PLANNING COMMISSION RECOMMENDATION FORM

**RE: Jefferson Avenue Subdivision Waiver Request Letter
Abington Township, Montgomery County, Pennsylvania
HCE Project No.: 1417**

Re: MCPC #19-0126-001
Plan Name: Jefferson Avenue Subdivision
(2 lots/2 dus comprising 0.40 acres)
Situate: 2907 Jefferson Avenue
Abington Township

**SUBJECT: 2907 JEFFERSON AVENUE
FINAL MINOR SUBDIVISION AND LAND DEVELOPMENT PLAN REVIEW NO. 1
ABINGTON TOWNSHIP, MONTGOMERY COUNTY, PENNSYLVANIA
PROJECT NO. 1926009R**

**4"/6" LATERAL CONNECTION
TO EXISTING VCP SEWER MAIN**

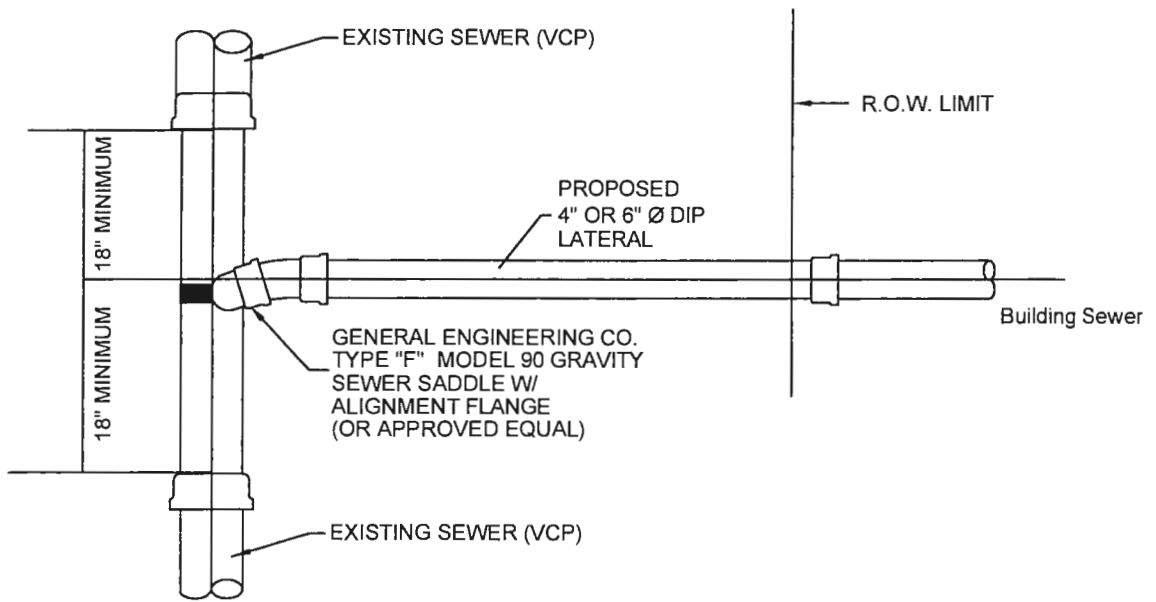
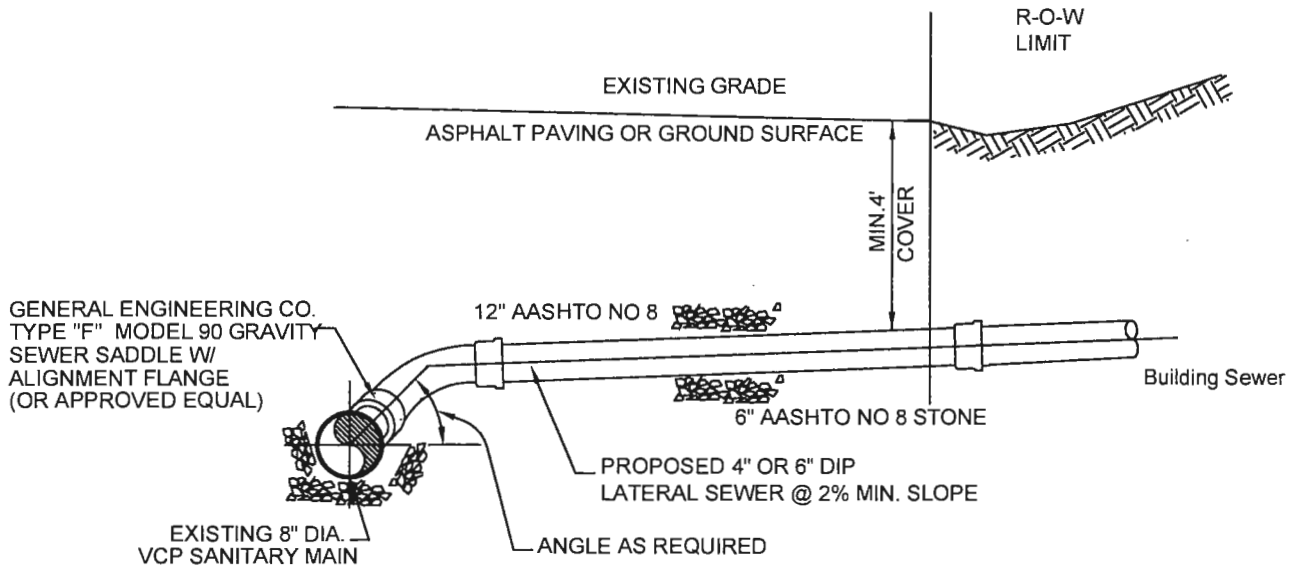
- The sanitary sewer pipe connection at the existing main for Lot 1 should conform to the enclosed Detail No. 33.
- All sanitary sewer pipe installations should conform to the enclosed Detail No. 1. All details shall be made part of the development plans.
- The plans state that the proposed water service size is 1". Please note that the sanitary sewer annual billing is based on the water meter size. Generally, the larger the water meter size, the higher the sanitary sewer costs.
